P & ID SERVICE WATER (WS)

WM. H. ZIMMER NUCLEAR POWER STATION UNIT 1
THE CINCINNATI GAS & ELECTRIC CO.
COLUMBUS & SOUTHERN OHIO ELECTRIC CO.
THE DAYTON POWER & LIGHT CO.

DRAWING NO. N-30
SHEET 3 OF 4

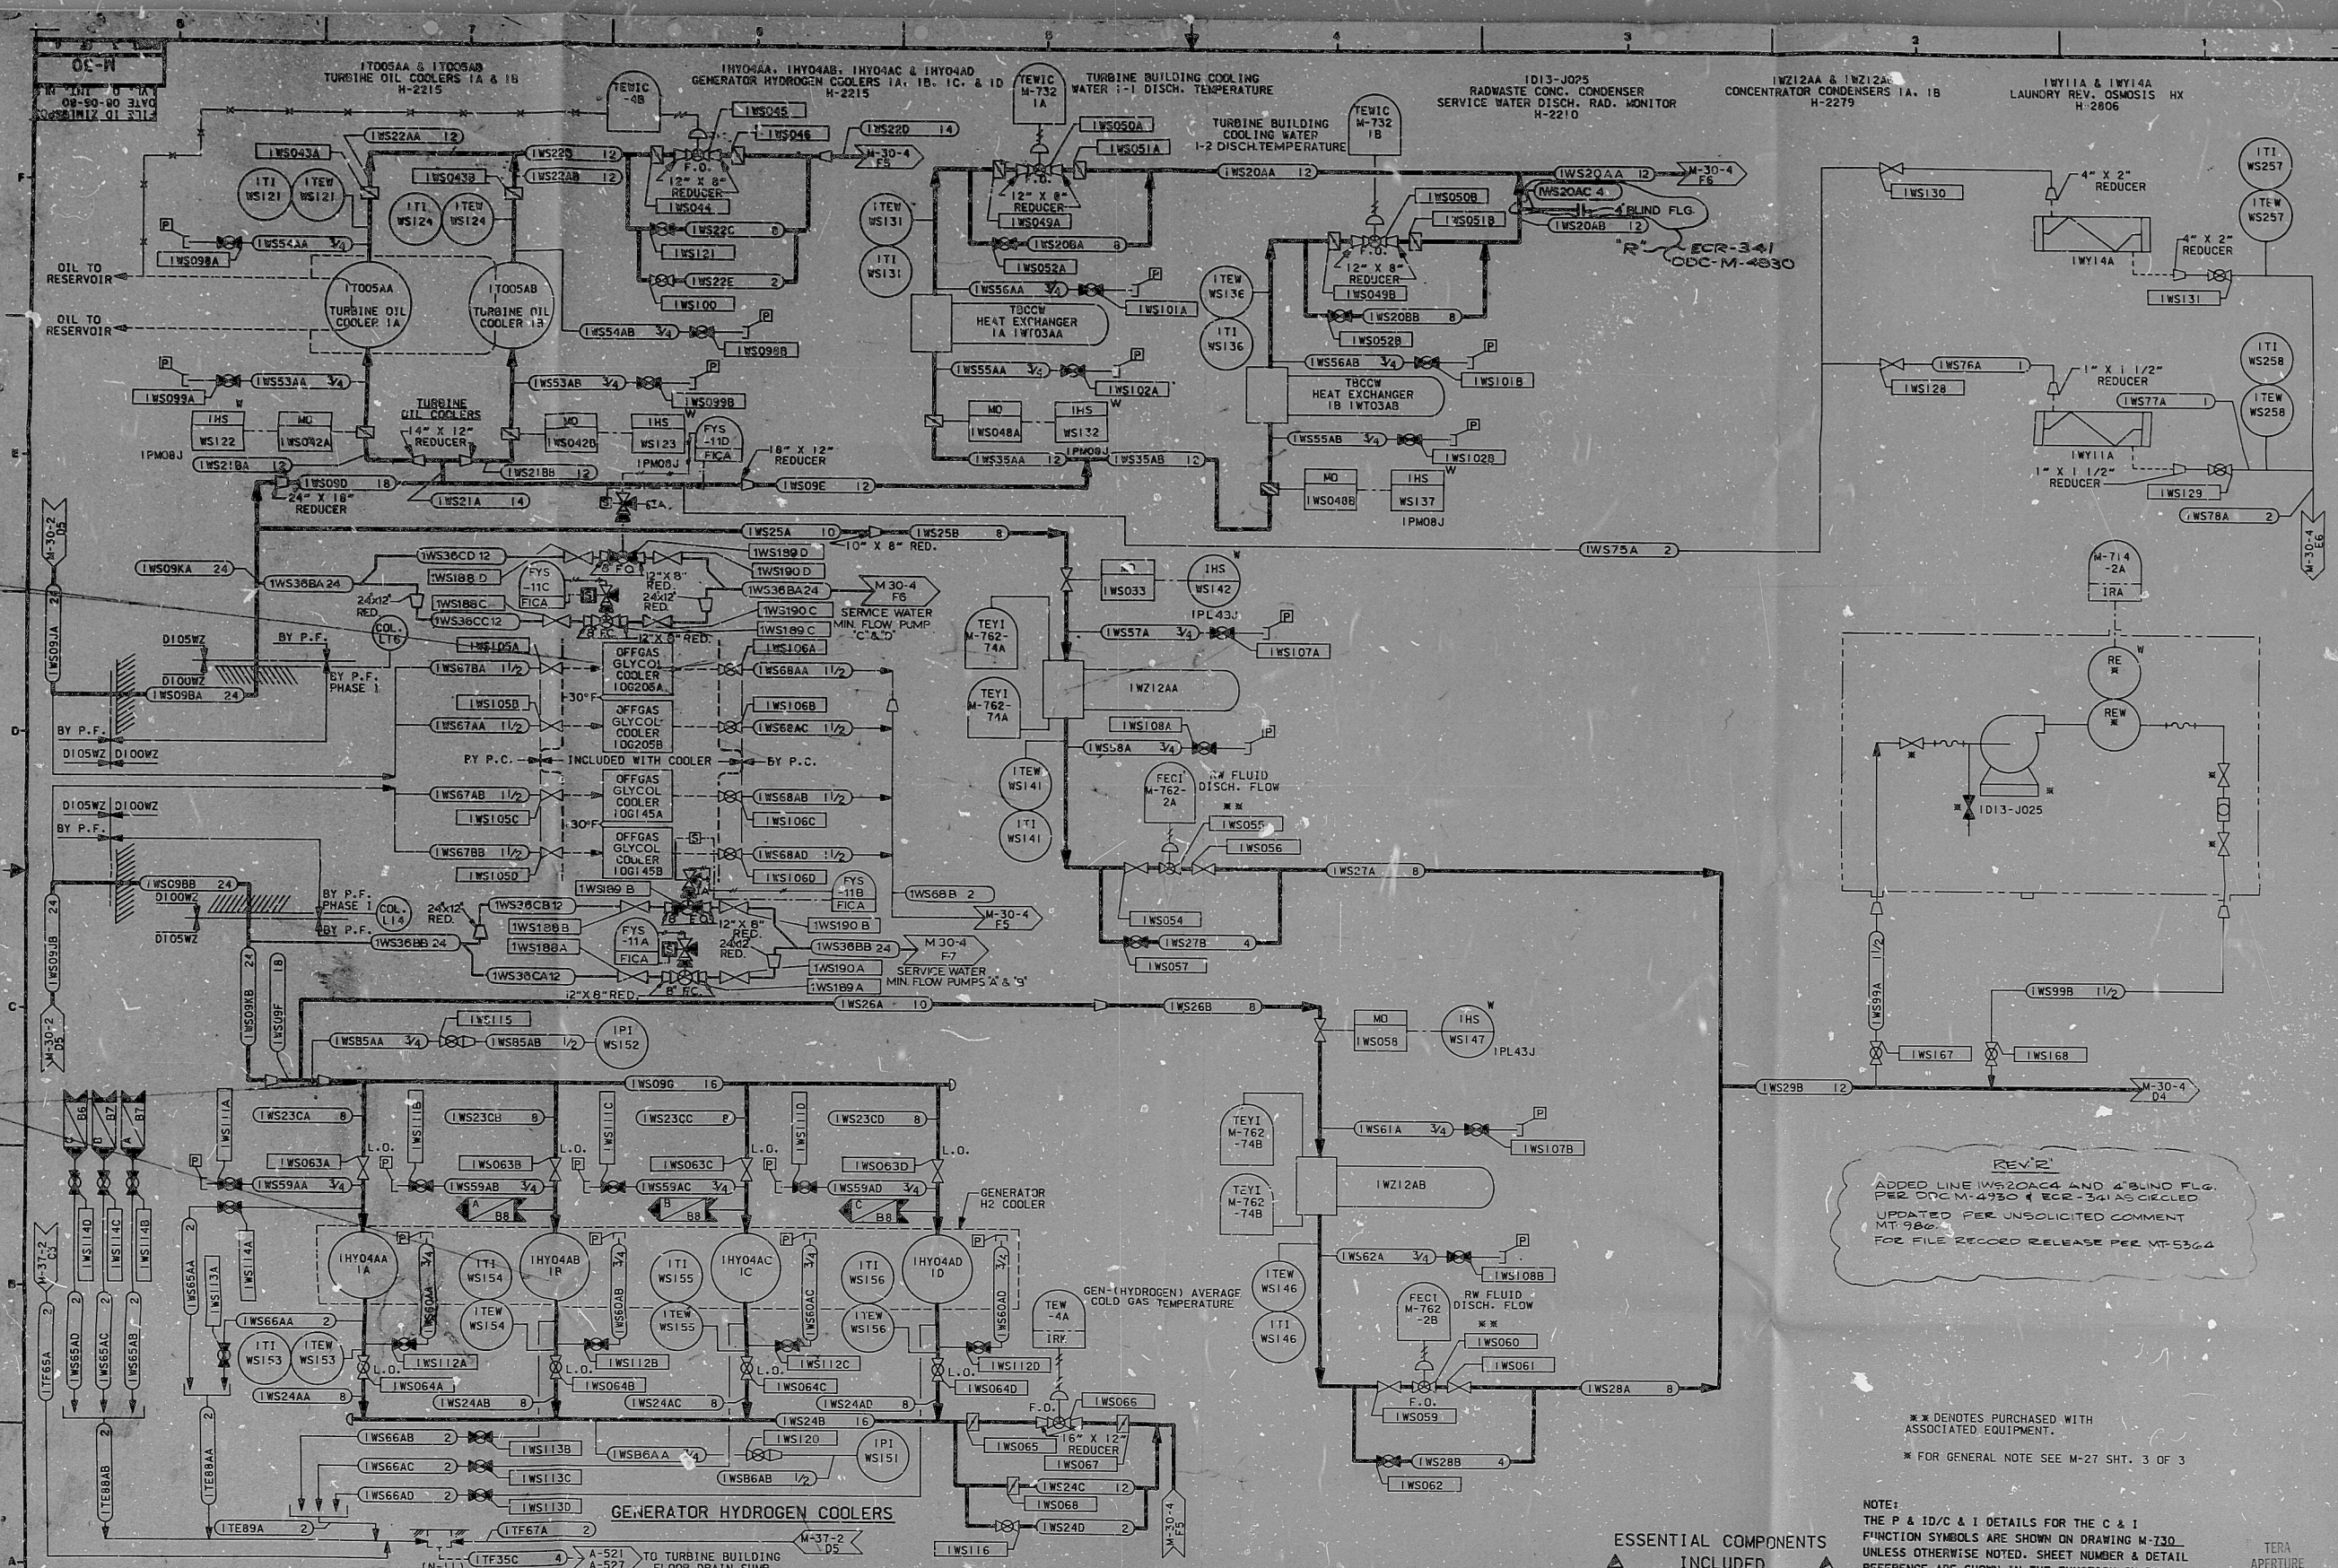
REV. 2
ADDED LINE IWS20AC4 AND 4" BLIND FLG. PER DDC-M-4930 & ECR-341 AS CIRCLED
UPDATED PER UNSOLICITED COMMENT MT-5364
FOR FILE RECORD RELEASE PER MT-5364
